Subject: Responses to Public Comments on Proposed updates for PCI 135, *Specification for Tolerances of Precast Concrete*.

Date: May 31, 2025

Oversight Committee: PCI Tolerances Committee	Document name: PCI- 135_Response_to_Public_Comments_20250531	PCI Contact: Edith Gallandorm	Finalized: May 15, 2025 *These responses have been approved by PCI TAC and QAC
--	--	---	---

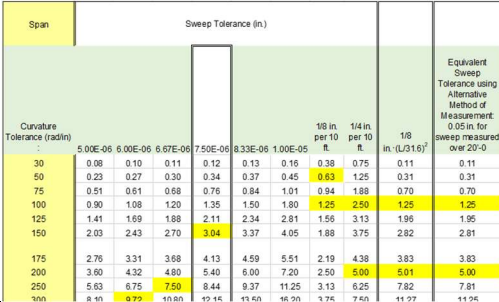
94	HW	4.3.1	In k_1 and k_2 change “panel” to “component” Also q_1 q_2 and r_1	No change. Figure is a panel.
95	HW	4.3.1	NSc_4 Suggest “along” the length as with the width. Also should there be a +0 as with the width	Agree. Change “to” to “along”. Add +0 in. (+0mm)
96	JC	4.3.2	Production tolerances for Fabricate ribbed structural precast concrete wall panels (Fig. 4.3.2) to the following production tolerances: shall be:	Agree. Change to: Production tolerances for Fabricate ribbed structural precast concrete wall panels (Fig. 4.3.2) to the following production tolerances: shall be:

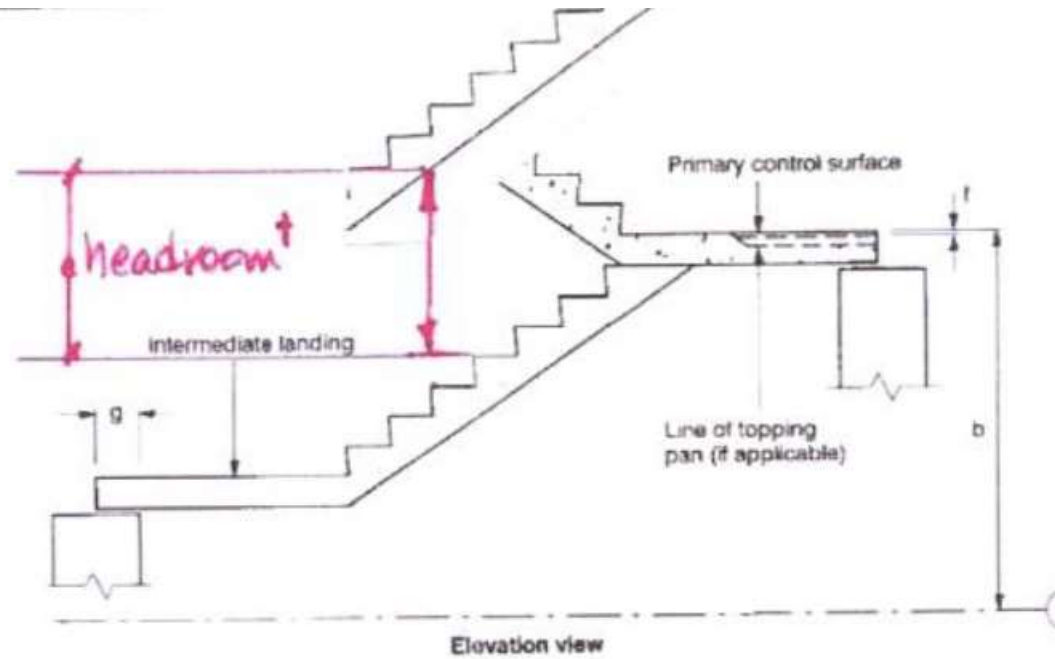
170	HW	5.3.8	f should read: Maximum jog in alignment of matching edges at the primary control surface	Agree. Comment form notes section 4.3.8, comments seem to apply to 5.3.8 Change to: f = Maximum jog in alignment of matching edges at the primary control surface+/- 1/4”
